HISTORIC AND DESIGN REVIEW COMMISSION

HDRC CASE NO: 2019-294
ADDRESS: 107 PASO HONDO
LEGAL DESCRIPTION: NCB 591 BLK 4 LOT 14
ZONING: RM-4, H
CITY COUNCIL DIST.: 2
DISTRICT: Dignowity Hill Historic District
APPLICANT: Cotton Estes/HighCotton Architects
OWNER: William Carson/CARSON WILLIAM M JR & CORBIN ANTHONY
TYPE OF WORK: Rear addition, foundation repair, wood window replacement, porch restoration
APPLICATION RECEIVED: May 17, 2019
60-DAY REVIEW: July 14, 2019
CASE MANAGER: Edward Hall
REQUEST:

The applicant is requesting a Certificate of Appropriateness for approval to:

4 SEC DTL @ FRONT PORCH SKIRT
SCALE: 1 1/2" = 1'-0" 1/ A507

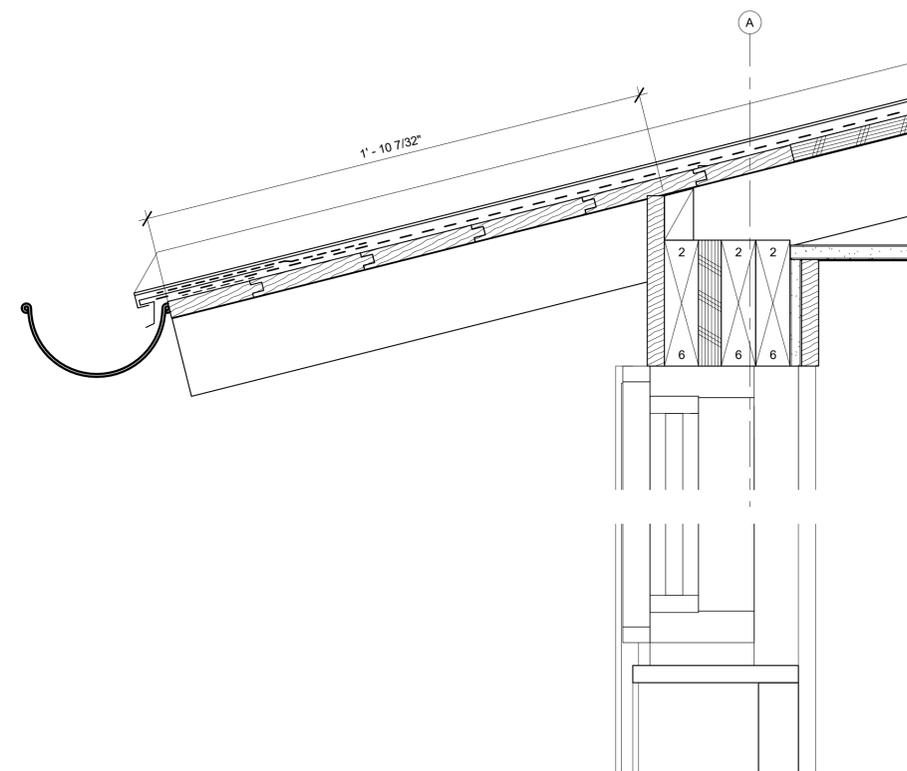
1. Perform foundation repair and install a wood, shiplap skirting to the front porch.
2. Perform rehabilitative scopes of work to the front porch including the removal of the existing, concrete porch steps, the installation of new tongue and groove decking, and the re-framing of the front porch.
3. Perform rehabilitative scopes of work to the brick masonry facades including repair to limestone window sills.
4. Replace the existing, standing seam metal roof in-kind.
5. Install skylights into the non-primary roof slopes of the roof structure.
6. Construct a rear addition to feature 70 square feet in size in the location of an existing, enclosed rear porch.
7. Replace the existing, wood windows with new wood windows.

COMPARISON OF EXISTING & PROPOSED WINDOWS:
(page 8 of the Historic Design Guidelines, Windows: Repair, Replacement, and New Construction)

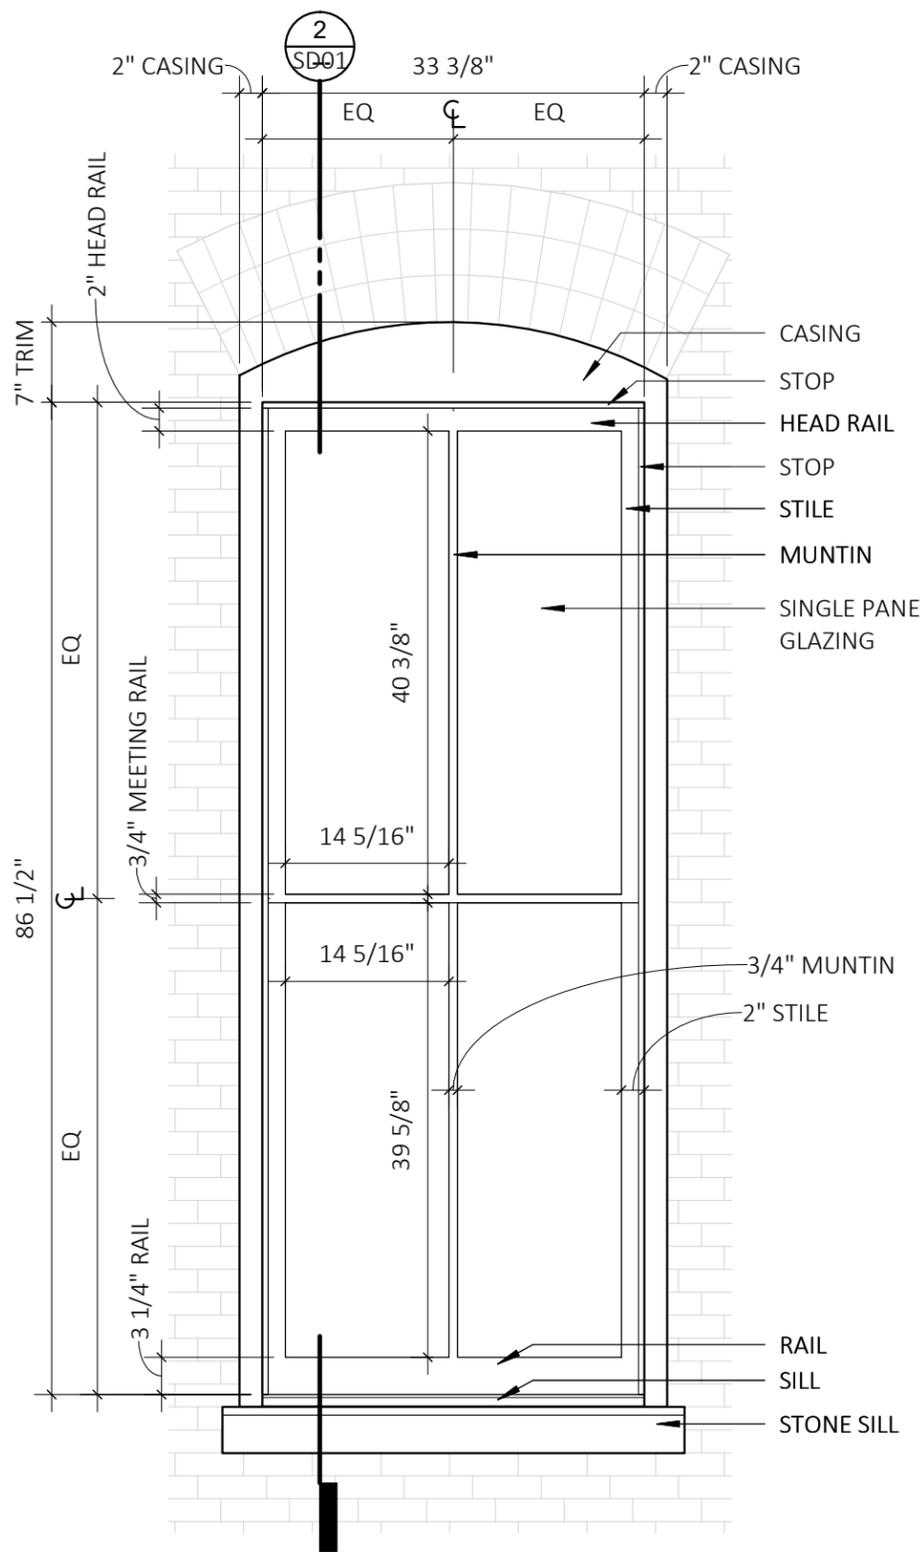
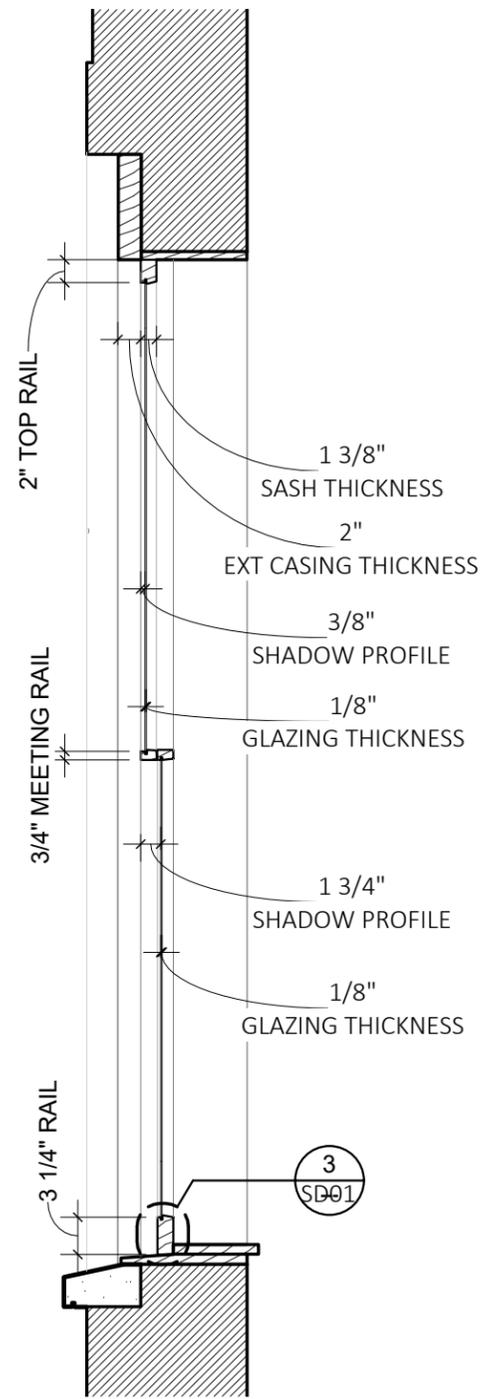
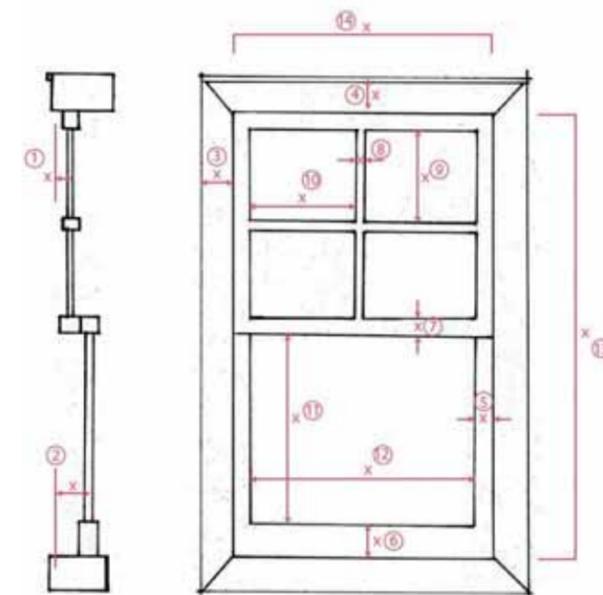
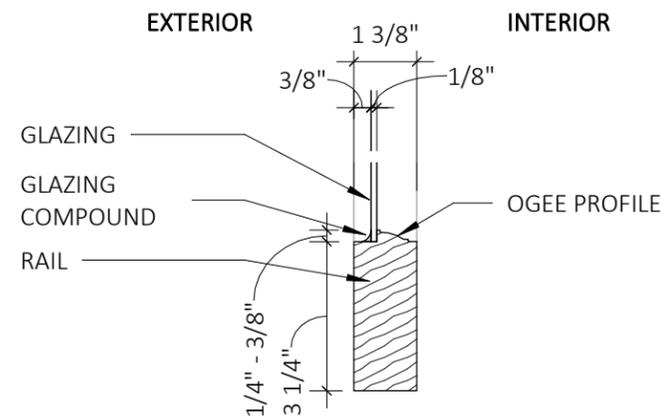
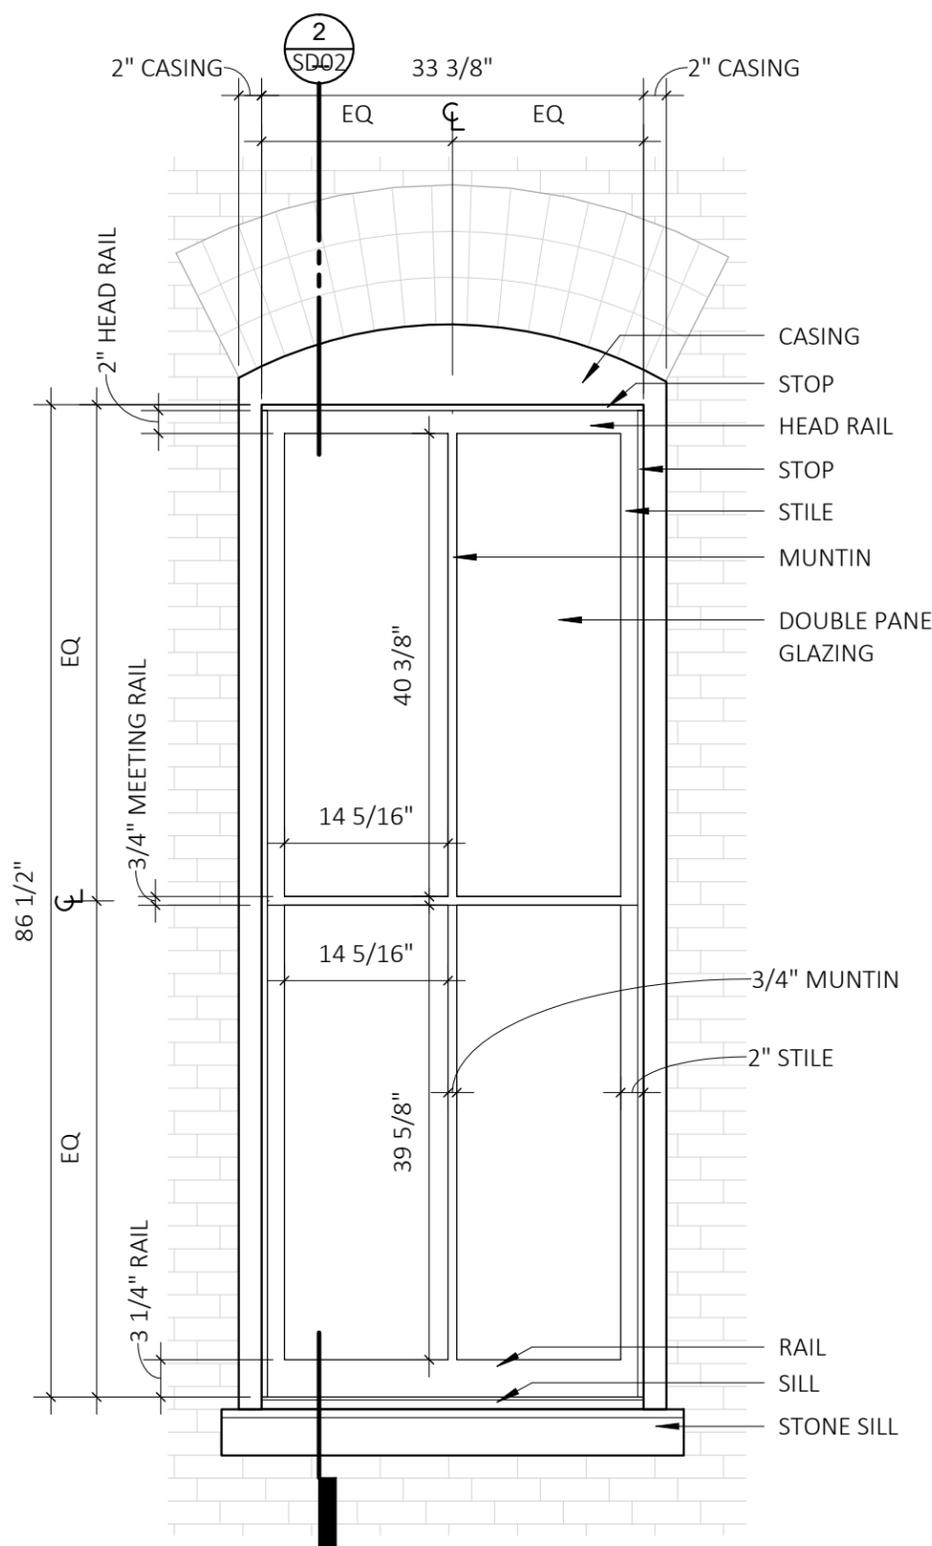
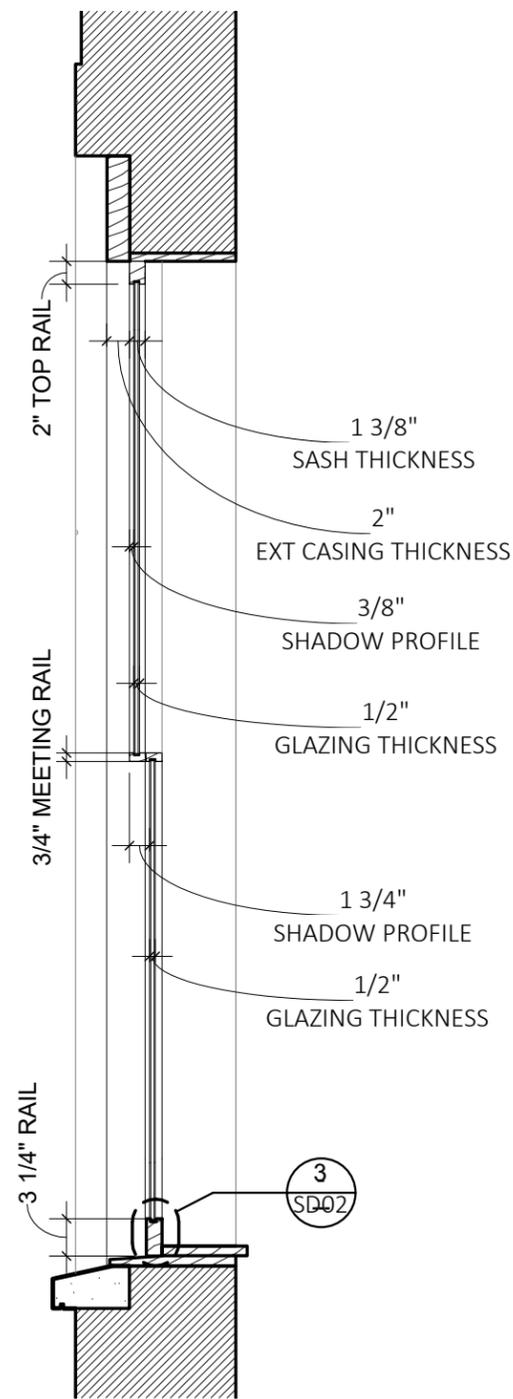
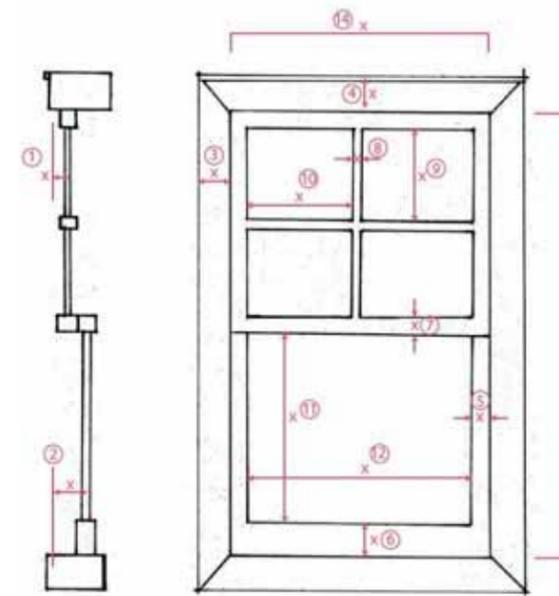
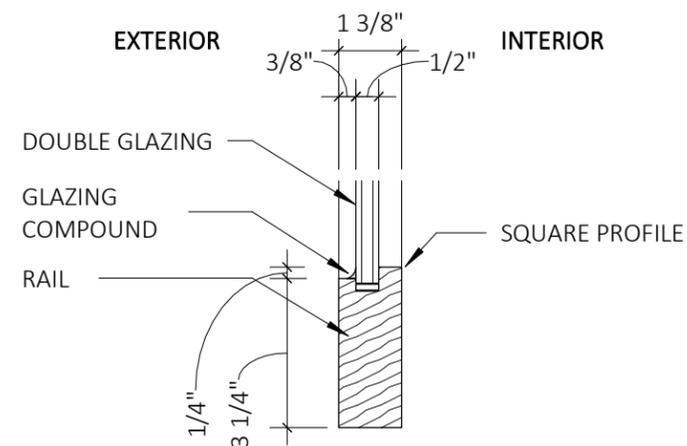
- n. WINDOW REPLACEMENT – The applicant has proposed to replace the existing, original wood windows with new wood windows featuring insulated sashes. The Guidelines for Exterior Maintenance and Alterations 6.A.iii. notes that historic windows should be preserved. Staff performed a site visit on November 26, 2018, where staff found the original windows to be in a repairable condition. Staff finds that the existing windows should be repaired and maintained within the historic structure.
